EVALUATION OF AMENDED RESPONSE AND UNSATISFACTORY VERIFICATION OF
CORRECTIVE ACTION REQUEST (CAR) YM-92-073 RESULTING FROM YUCCA MOUNTAIN
QUALITY ASSURANCE DIVISION (YMQAD) AUDIT YMP-92-22

CORRECTIVE ACTION REQUEST

RESPONSE TO ISSUANCE OF CORRECTIVE ACTION REQUEST (CAR) YM-092-073 RESULTING
FROM YUCCA MOUNTAIN QUALITY ASSURANCE DIVISION AUDIT YMP-92-22 OF SANDIA
NATIONAL LABORATORIES

FIGURE 1. RELATIONSHIP OF STRATIGRAPHY, LITHOLOGY AND HYDROSTRATIGRAPHIC ZONES AT G-4
(Adapted from SNL [1991], Figure 3-5)

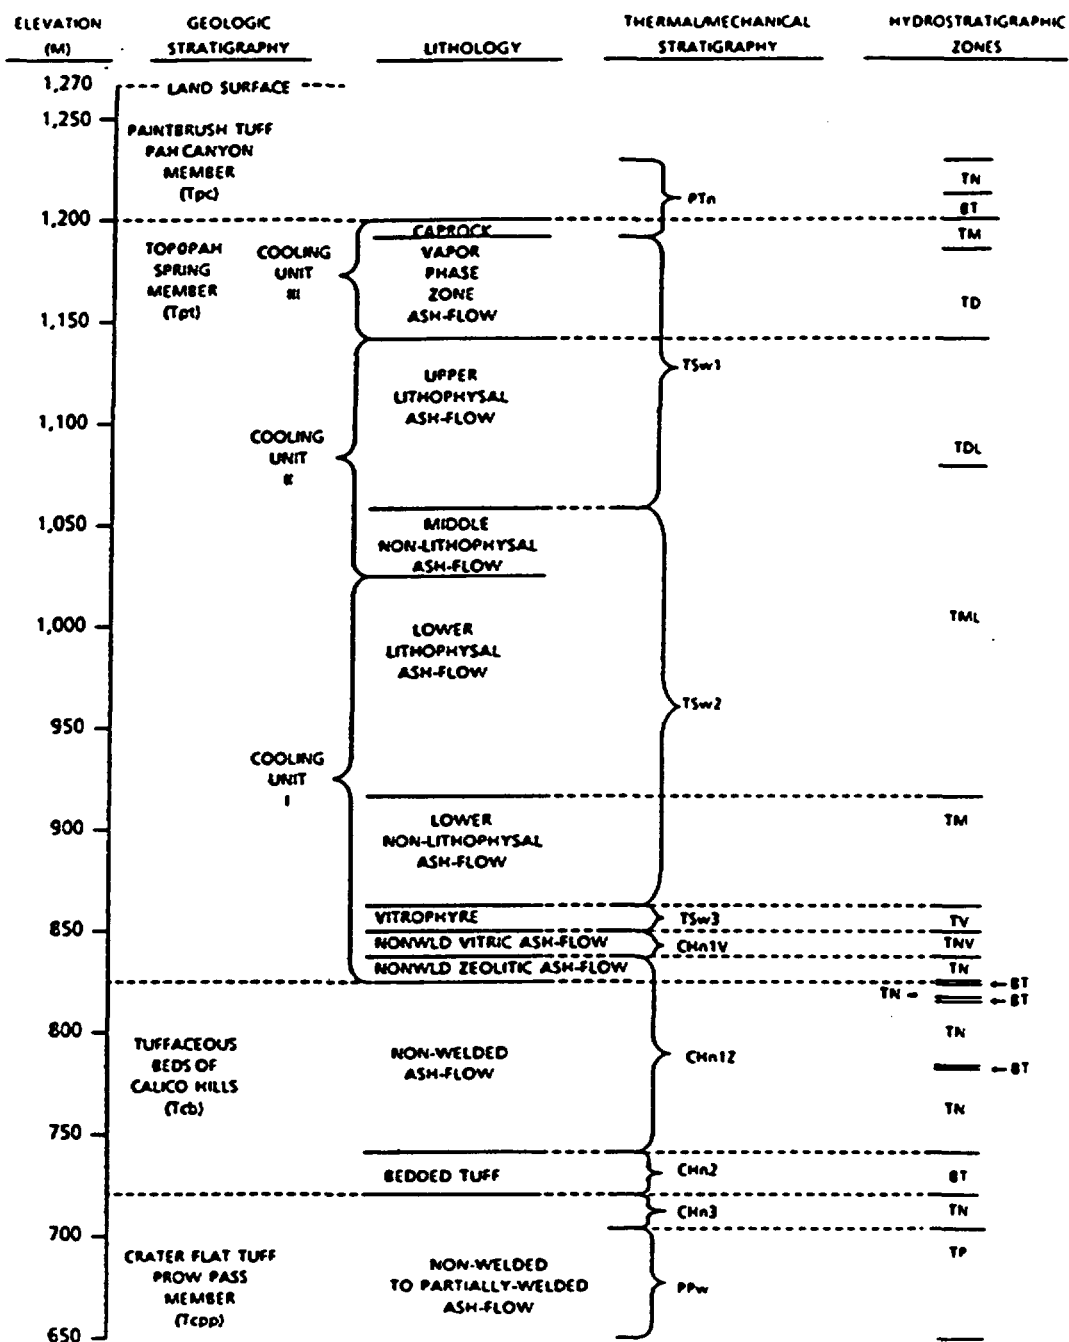
1 Controlling Document QARD, Revision 4		2 Related Report No. Audit YMP-92-22	
3 Responsible Organization YMP		4 Discussed With A. Simmons	
5 Requirement: The QARD, Revision 4, Appendix A, Paragraph 20.1.B.6 states planning measures include: "The evaluation of data quality to assure that generated data is valid, comparable, complete representative, precise and accurate."			
6 Adverse Condition: The Reference Information Base (RIB), Version 4, Revision 6, contains different values for Thermal/Mechanical Stratigraphy data for Borehole USW G-4. Stratigraphy depths found in Table 1 "Thermal/Mechanical Stratigraphy for Borehole USW G-4" (found in chapter 1, section 1, item 2, page 2 of 3) does not agree with the "Thermal/Mechanical Stratigraphy" values in Figure 1 "Relationship of Stratigraphy, Lithology and Hydrostatigraphic Zones at G-4" (found in chapter 1, section 4, item 4, page 3 of 6) in all cases.

Although no QA requirement has been breached, it is recognized that there is a potential for misuse of information presented in Figure 1 of Item 1.4.4. I appreciate the fact that the audit results pointed this out. Steps will be taken, in accordance with Yucca Mountain Site Characterization Project Administrative Procedure 5.3Q, to rectify the problem.

- A. Remedial Action - Delete RIB Item 1.4.4 Hydrogeologic Zones. This action removes the apparent inconsistency described in the CAR.
- B. Investigative Action - Principal Investigators at SNL reviewed the information contained in Items 1.1.2 and 1.4.4 of the RIB. The conclusion of the review was that a more detailed technical assessment was necessary to recommend changing either Item. Because the RIB contains the best available data at a given point in time, it was determined that the best available Stratigraphic Data is contained in RIB Item 1.1.2 which has more utility at this time than RIB Item 1.4.4. Therefore, to eliminate an apparent inconsistency, RIB Item 1.4.4 will be removed. Updated hydrogeologic data will replace the current information as it becomes available.
